CALIFORNIA COASTAL COMMISSION

STAFF REPORT AND RECOMMENDATION  
ON CONSISTENCY DETERMINATION

Consistency Determination  
 No. CD-105-95  
 Staff: LJS-SF  
 File Date: October 26, 1995  
 45th Day: December 10, 1995  
 60th Day: December 25, 1995  
 Commission Meeting: Dec. 14, 1995

DEVELOPMENT DESCRIPTION: General Management Plan for Cabrillo National Monument (N.M.) (Exhibits 2-9)

**Alternative B**  
**Development Concept Plan 2**  
**ADMINISTRATION SPACE ADDITIONS**  
**Storage Building: Site Plan**

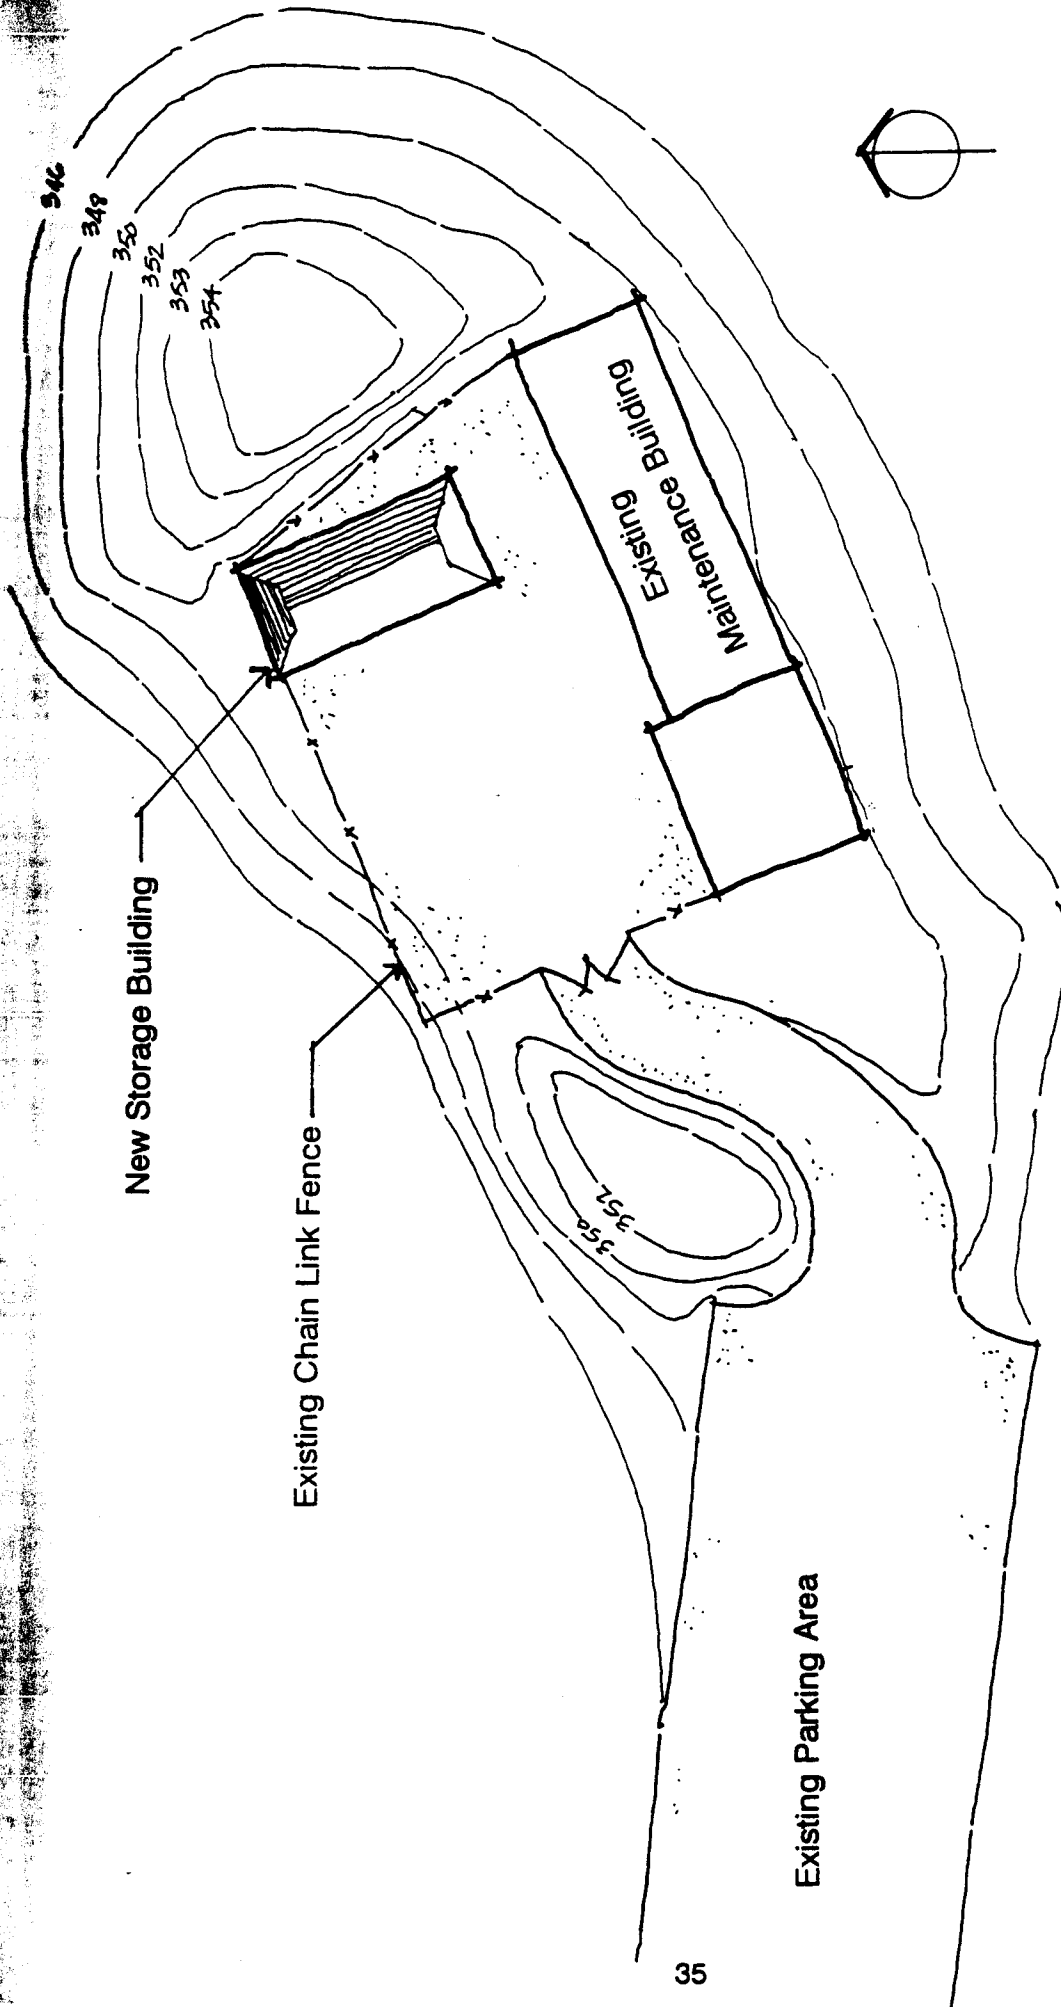
- \* Old Maintenance Site: A 1150 square-foot storage building would be constructed at the old maintenance site (adjacent to an existing maintenance building) for the monument's museum collection and the Cabrillo Historic Society (Exhibit 8).

**Alternative B**  
**Development Concept Plan 5**  
**BAYSIDE TRAIL LOOP: ALIGNMENT**

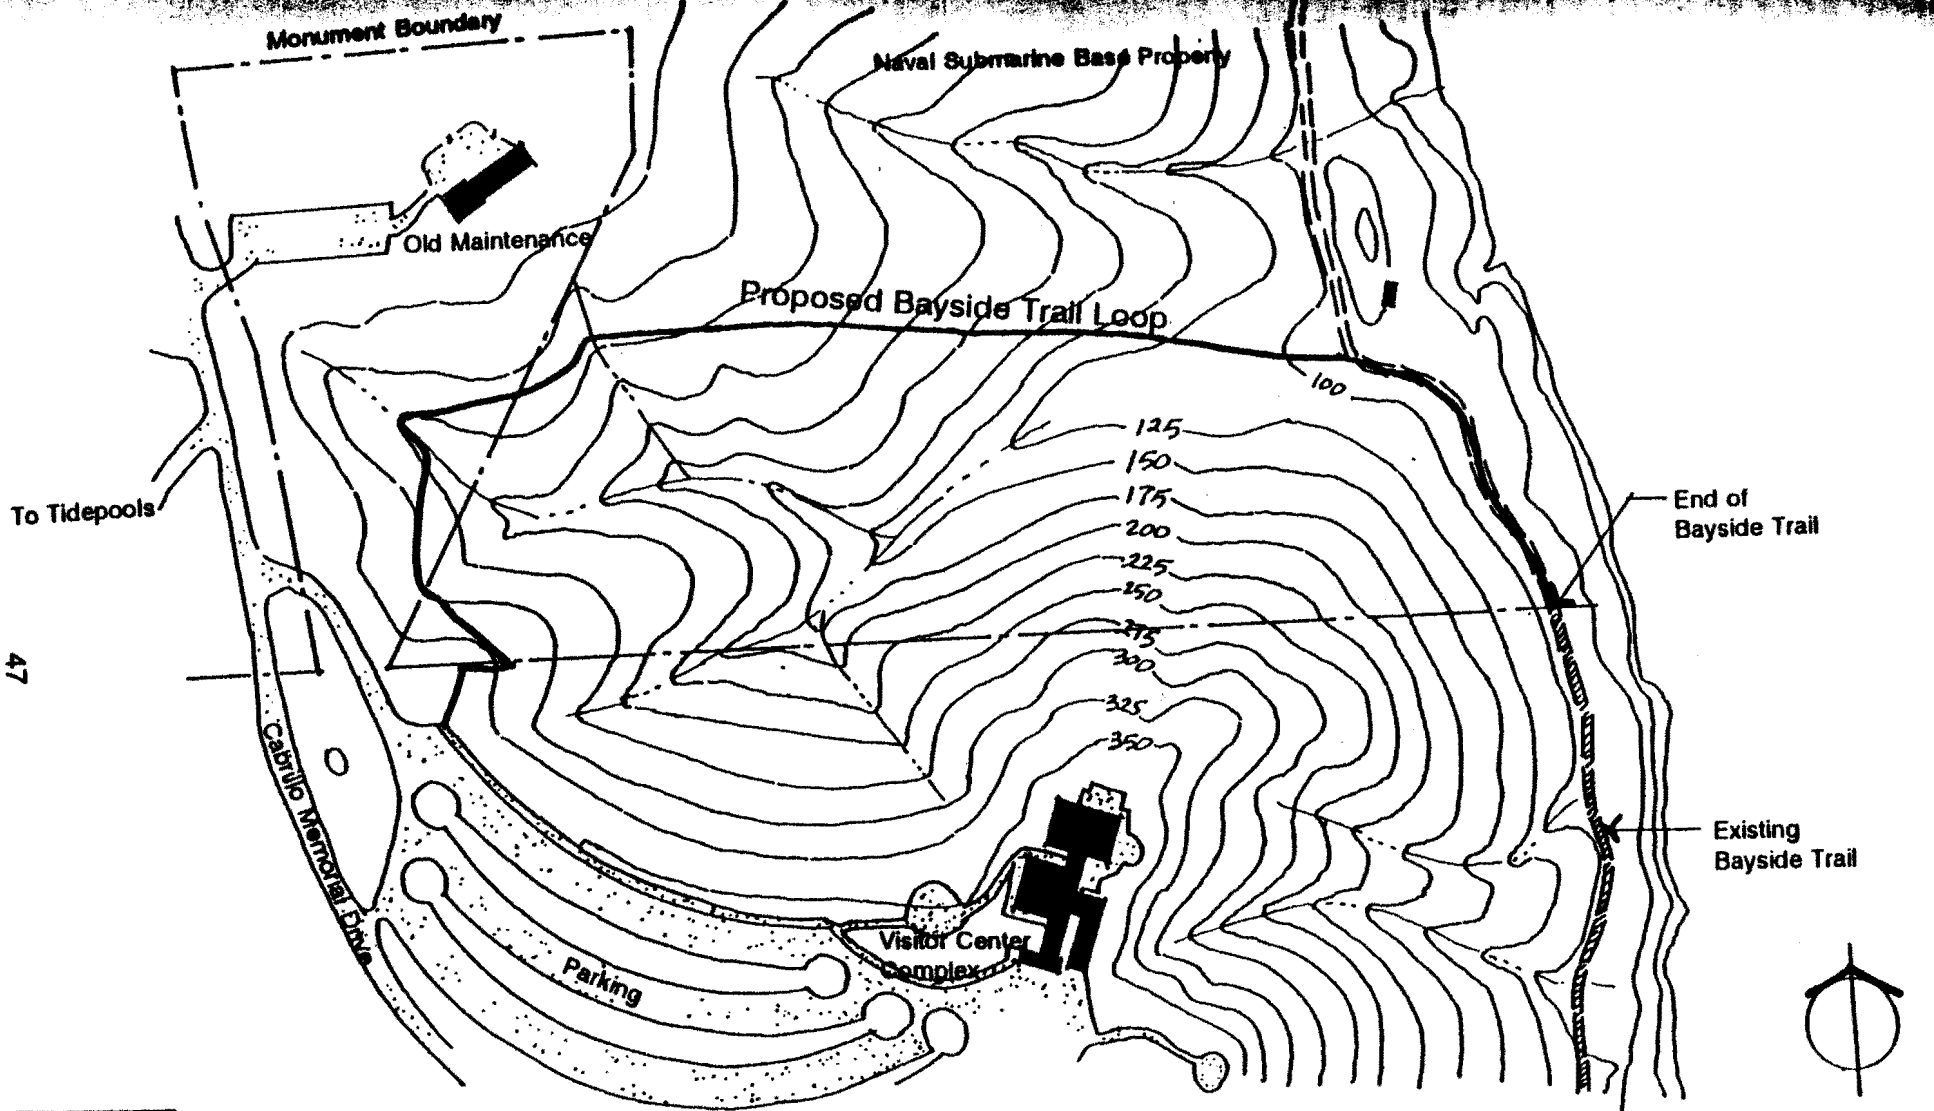
- \* Trail Plan: The Bayside Trail, which now ends at the boundary between the monument and the Naval Submarine Base, would be extended up to the monument's main parking area to create a loop trail. This project would not be implemented until access easements are made between the Navy and NPS. In addition, the plan calls for linking appropriate points of interest in a trail system, and eliminating and revegetating numerous social [i.e., informal] trails that have developed over time (Exhibit 9).

Construction of an extension to the Bayside Trail making it a loop trail would enhance the visitors' recreational experience and provide access to excellent views. Construction of a Bayside Trail loop would temporarily expose approximately 8400 square feet of soil to erosion by removing coastal sage scrub vegetation. An approximate 2100 foot linear corridor, varying in width from three feet to seven and one-half feet wide (including back slope, trail bench, and fill slope), would be opened to soil erosion and invasion of exotic plant species. The back and fill slopes would be revegetated with native plant materials removed during construction, leaving a generally 2-foot wide trail. Over the long term, about 4200 square feet, the trail tread itself, would be exposed. Potential erosion would be mitigated through selection of a steady, straight grade rather than switchback design, gaining almost all changes in grade with steps, and installation of a drainage system. Effects on wildlife would be expected to be minimal.

The Commission acknowledges that extending the Bayside Trail to make it a loop trail would be a positive benefit for visitors to the monument, but at the same time would require the elimination of sensitive coastal sage scrub habitat. The NPS also proposes to eliminate numerous social trails within the monument and restore those areas to coastal sage scrub habitat. As a result, there appears to be a basis for developing a mitigation program for the loss of coastal sage scrub habitat within the larger context of the General Management Plan. The Commission believes that the NPS has, at this GMP stage of its planning process, designed a trail plan that appears to be consistent with the environmentally sensitive habitat policies of the Coastal Act. However, the Commission additionally finds that before it can determine that the proposed trail plan and resulting loss of native plant habitat are fully consistent with those Coastal Act policies, a greater level of detail regarding this plan, its potential coastal zone effects, and the proposed mitigation for those effects must be provided by the NPS.
